ICC 2021 Code Changes

This document created by the Florida Department of Business and Professional Regulation -
850-487-1824

TAC: Roofing

Total Mods for **Roofing** in **Pending Review**: 52

Fascia on 6" wide by 4" high "Parapet"

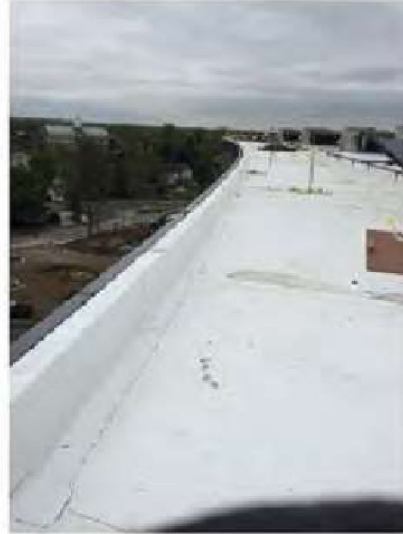
This revision will provide additional options for maintaining a continuous air barrier. For example, the roof membrane could be used to wrap the top of the parapet wall and extend down the exterior side of the wall. The membrane could then be tied into the wall air barrier system. See also Figures 1 through 4.

FIGURE 3114.8.5.3(1)
BRACING UNIT DISTRIBUTION—MAXIMUM LINEAR LENGTH

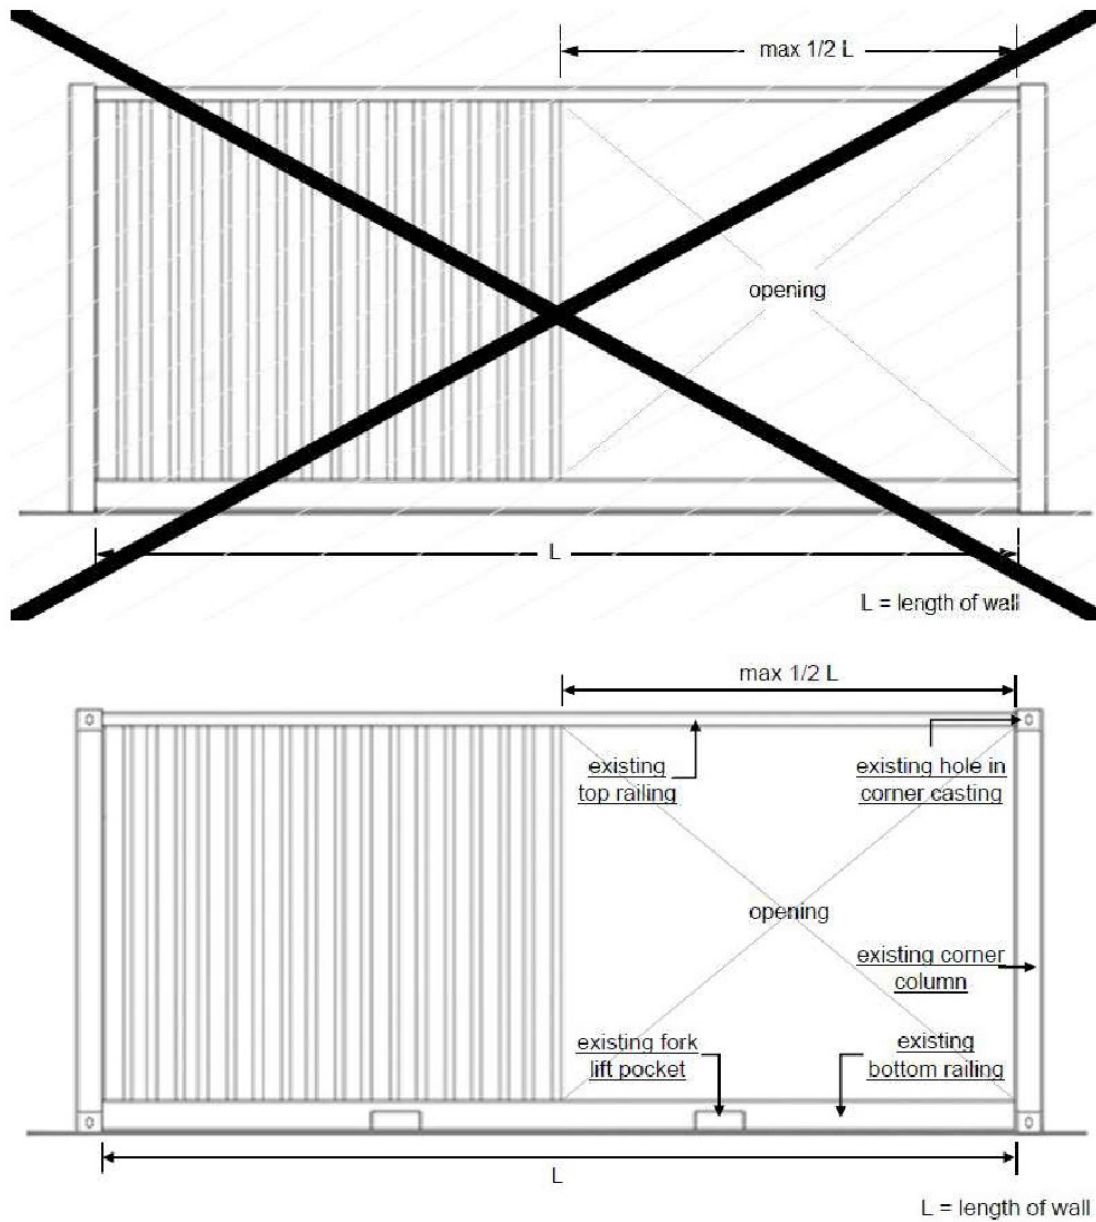
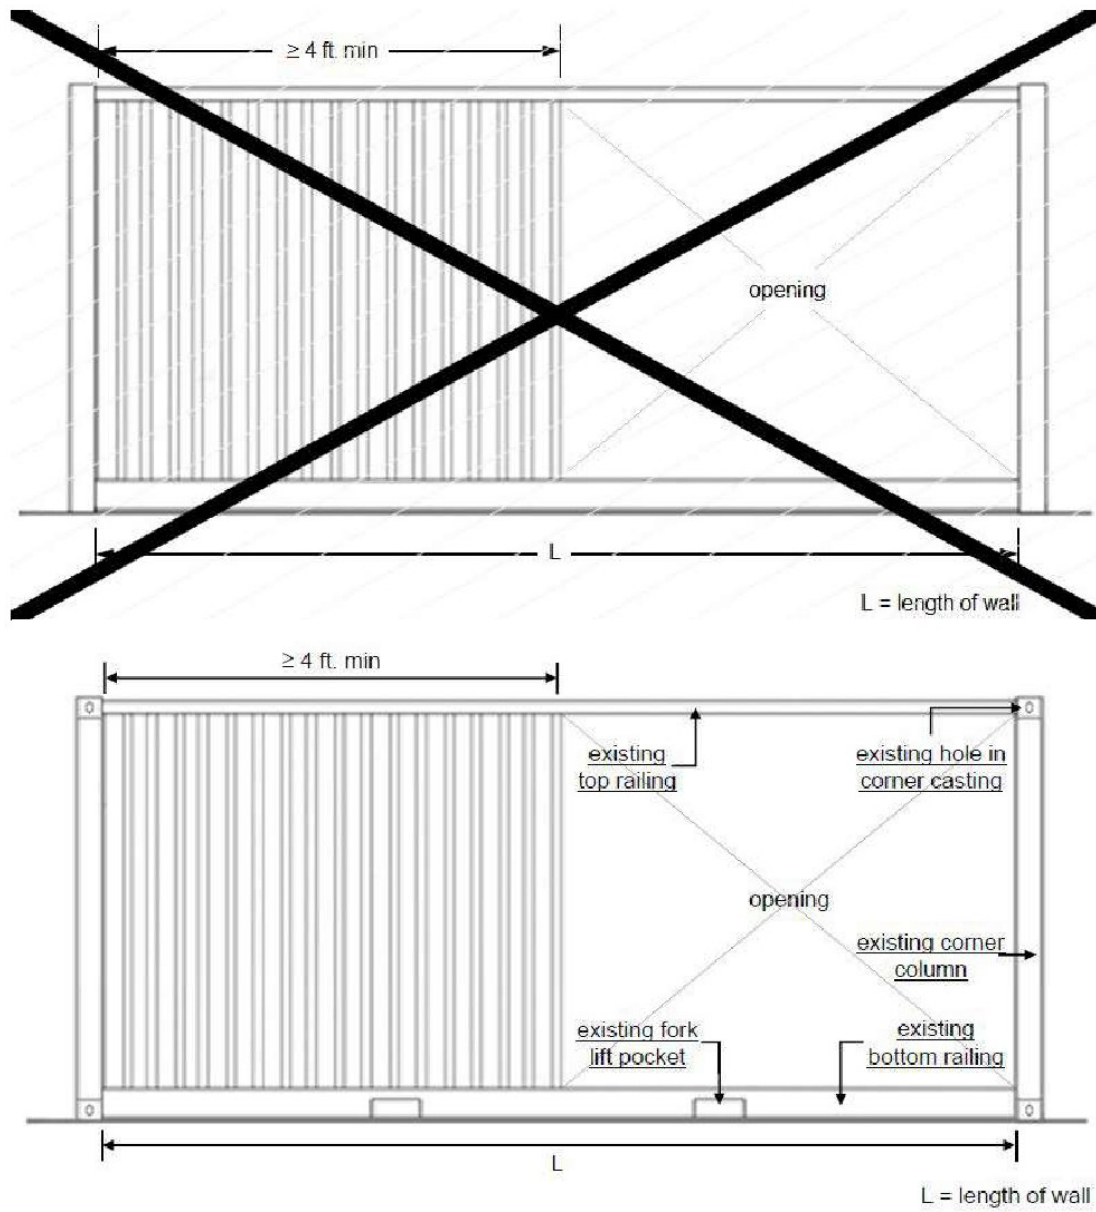
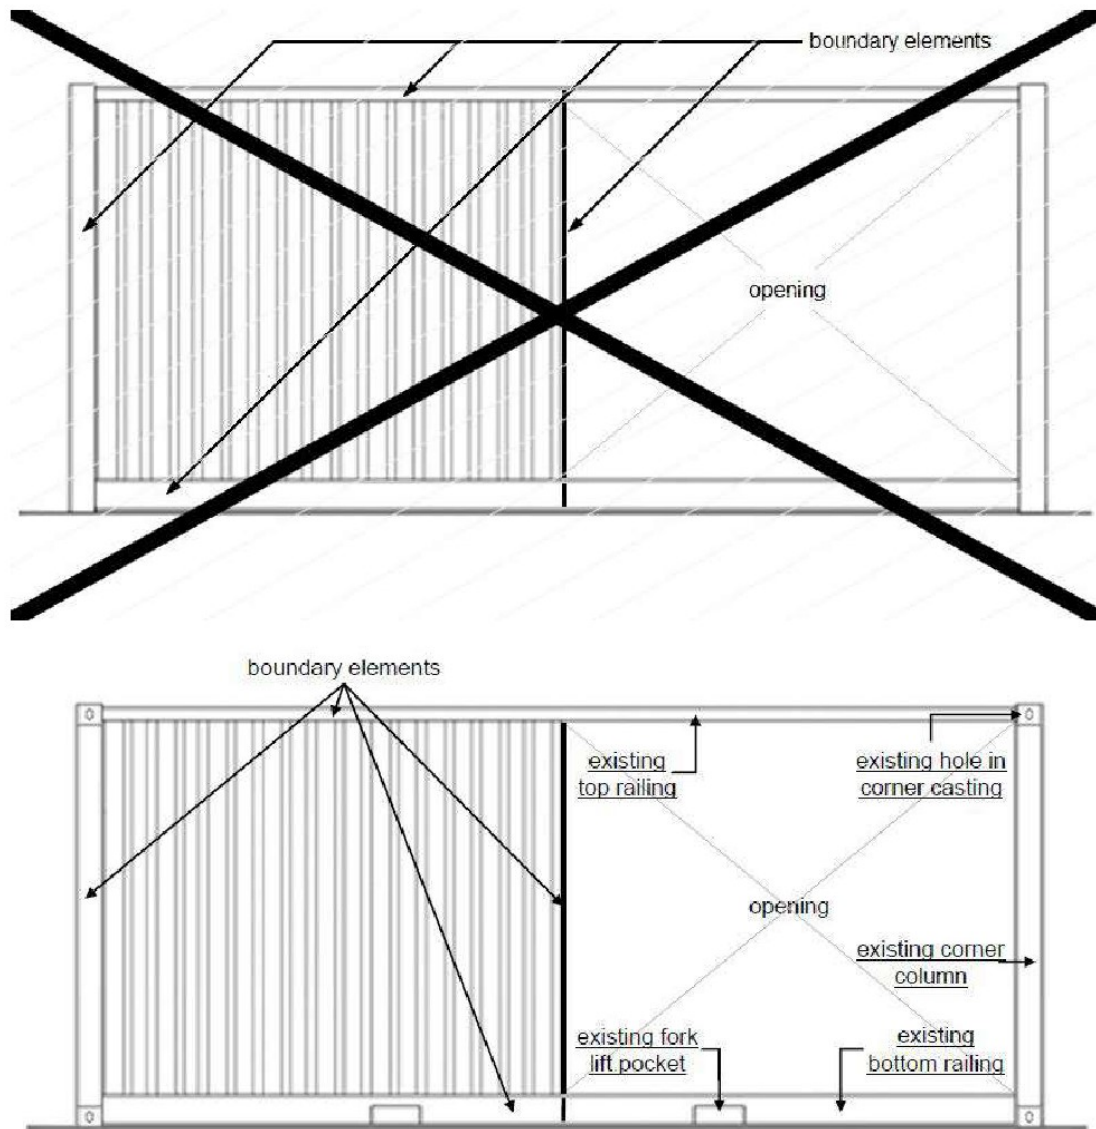
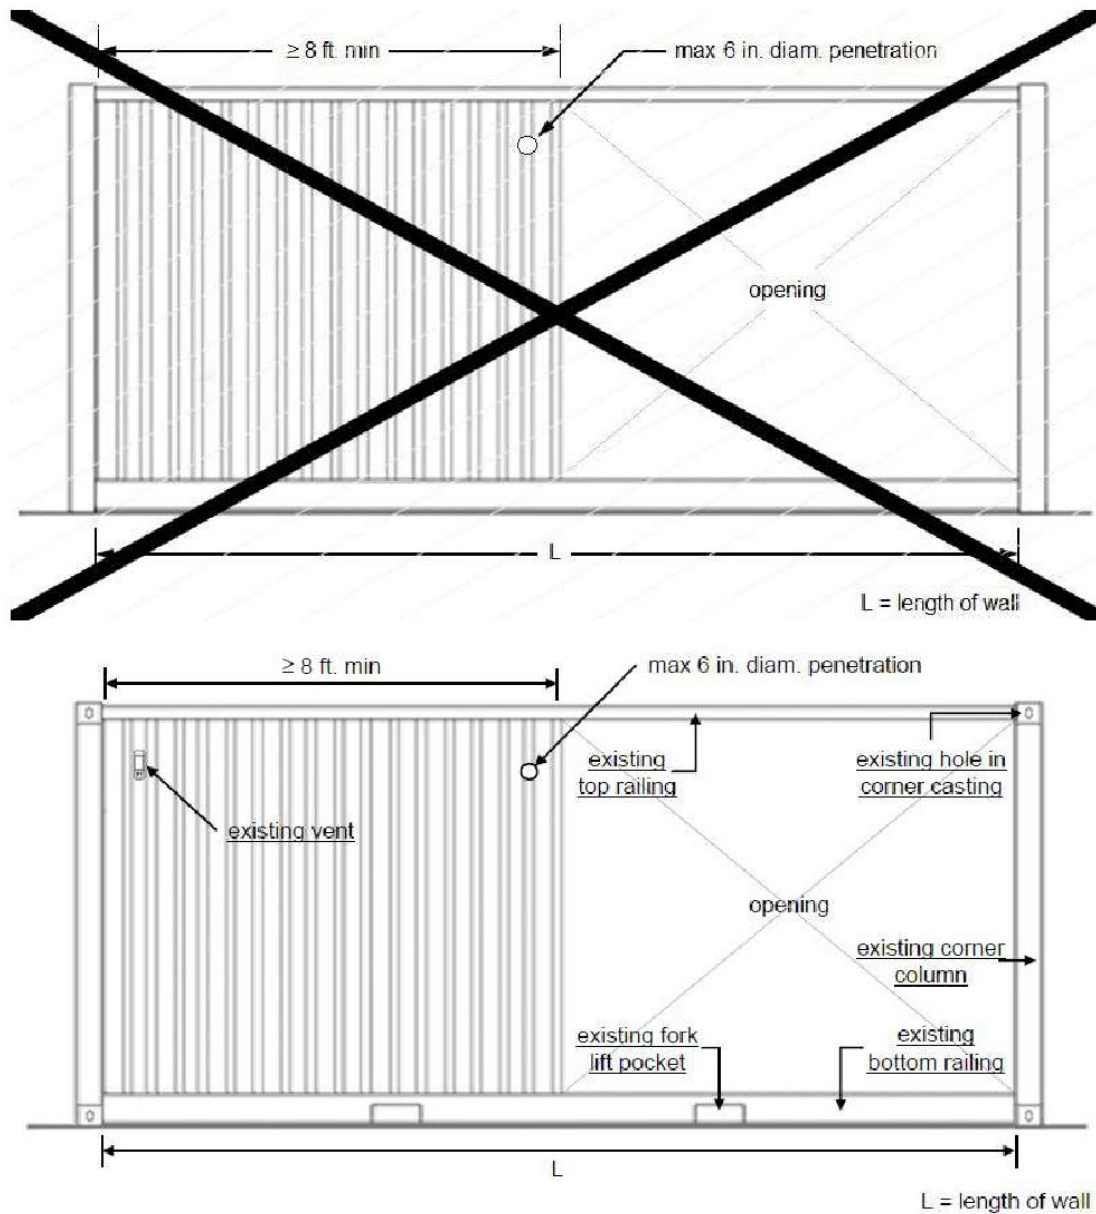
Figures 3114.8.5.3 (1) through (4) – It was brought to our attention that it may be beneficial to identify parts of the intermodal shipping container more clearly rather than use a simple line drawing figure. This is for the benefit of the user to more readily recognize existing conditions versus the permissible cut-aways as allowed by Section 3114.8.5.3. In response we are proposing to add identifying text (the rails, lift slots, and holes) to illustrate those existing elements that are part of the manufacture of intermodal shipping containers.
